June 22, 2010  
Subject: **Bangor & Brewer**  
Federal Project No: IM-1709(900)E &  
IM-1710(000)E  
State Pin No: 017099.00 & 017100.00  
**Amendment No. 1**

STATE OF MAINE  
DEPARTMENT OF TRANSPORTATION  
**IM-1709(900)E & IM-1710(000)E**  
BRIDGE NO. 5799 PIN  
BRIDGE NO. 1558 **17099.00 & 17100.00** BRIDGE PLANS

MAIN STREET & VETERANS REMEMBRANCE BRIDGE  
MAIN STREET & PENOBSCOT RIVER  
BANGOR - BREWER PENOBSCOT COUNTY  
**ESTIMATED QUANTITIES**

VETERANS REMEMBRANCE BRIDGE  
 PENOBSCOT RIVER  
 BANGOR-BREWER PENOBSCOT COUNTY  
**EXPANSION JOINT & CURTAIN TROUGH DETAILS**

SHEET NUMBER  
**17**  
 OF 28

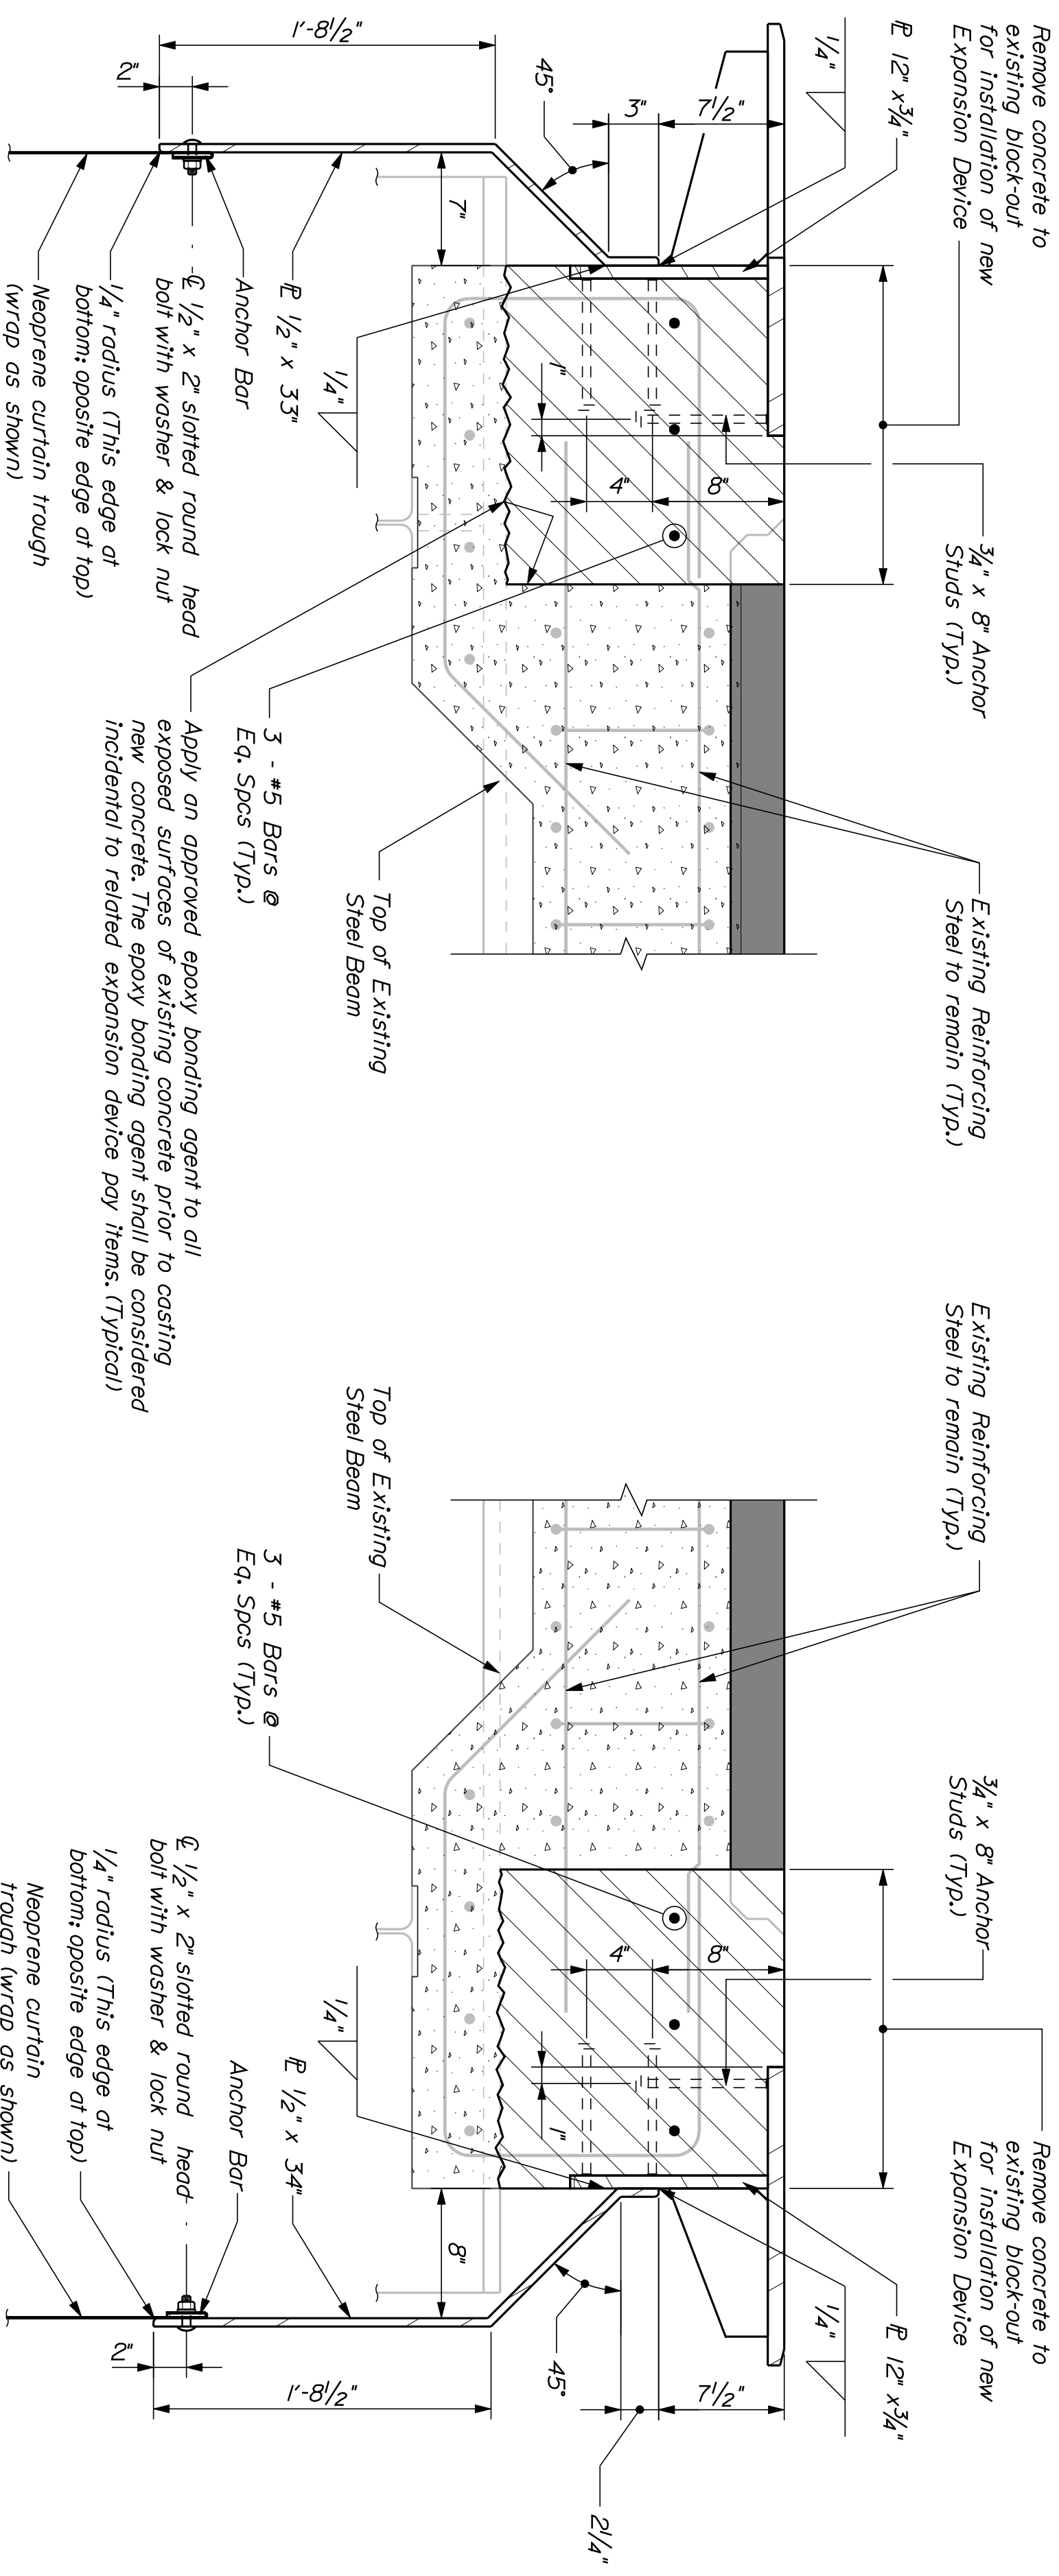
**Question:** Can you advise on where to find details for finger joints?

**Response:** Most details for the finger joints are covered by standard details. See MaineDOT standard detail book pages 521(01) to 521(11) for details of finger joints. For project specific details regarding the finger joints see the following pages of the plans: Pages 13, 17, 18 and 19.
